GREEN LAKE PROJECT (P7189)

APPENDIX A – DLA RESPONSES

This appendix contains the comments GLWP received on the Draft License Application (DLA) and GLWP's responses to those comments.

Here is a picture of the road to the dam, along the wood stave penstock:

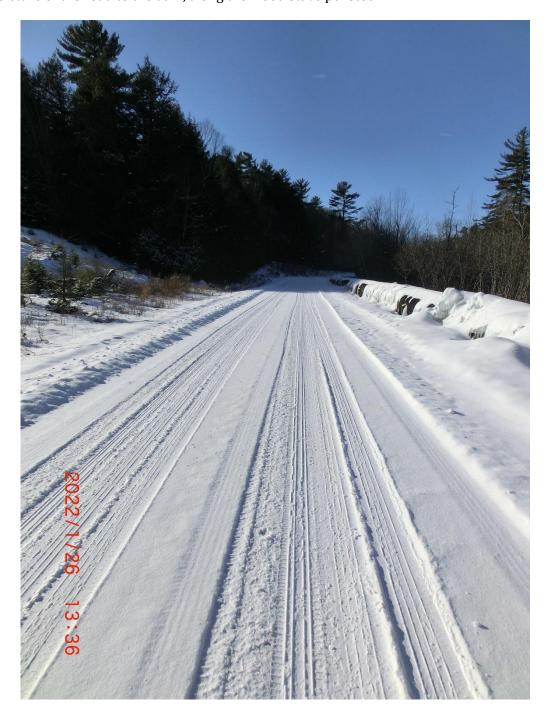
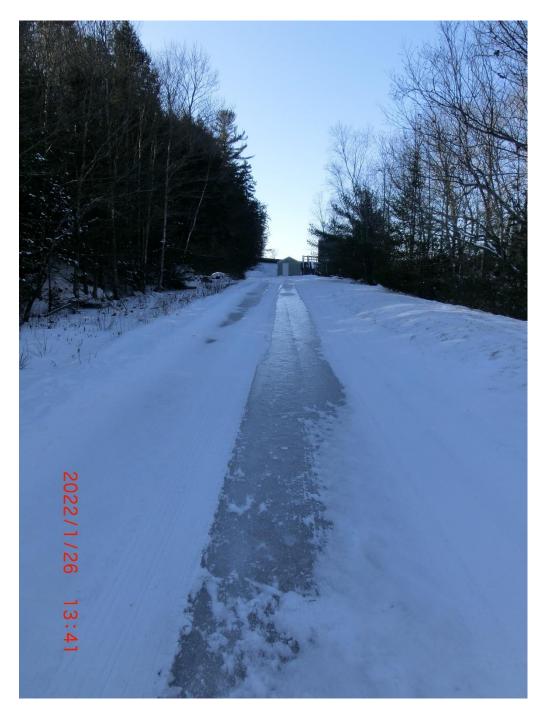
The Service appreciates the Applicant recognitions that the wood stave penstock will need to be repaired or replaced. The Service appreciates the Applicant's efforts to maintain the existing wood stave penstock and patch the leaks; however, the leaks represent a substantial loss of water, create safety issues related to ice build-up, and have caused bank erosion. Therefore, the Service requests that GLWP include in its FLA, plans to repair or replace the wooden stave section of thepenstock and the leaking 8-foot square concrete transition block located between the end of the 48-inch concrete penstock and the wood stave penstock.

The first pictures were taken 26-Jan-2022, the day after USFWS filed its DLA comments.

On the road just below the dam the wind has scoured the snow, revealing the ice that is underneath the snow in these pictures. The penstock is under ground at this point. Here are two pictures of the road near the dam:

The snow was from the day before. The ice under the snow was from a storm that occurred about one week earlier on 17-Jan-2022. It does not show clearly in the picture above, but the layer of ice in the pictures of the road near the dam is present on the parking lot as well.
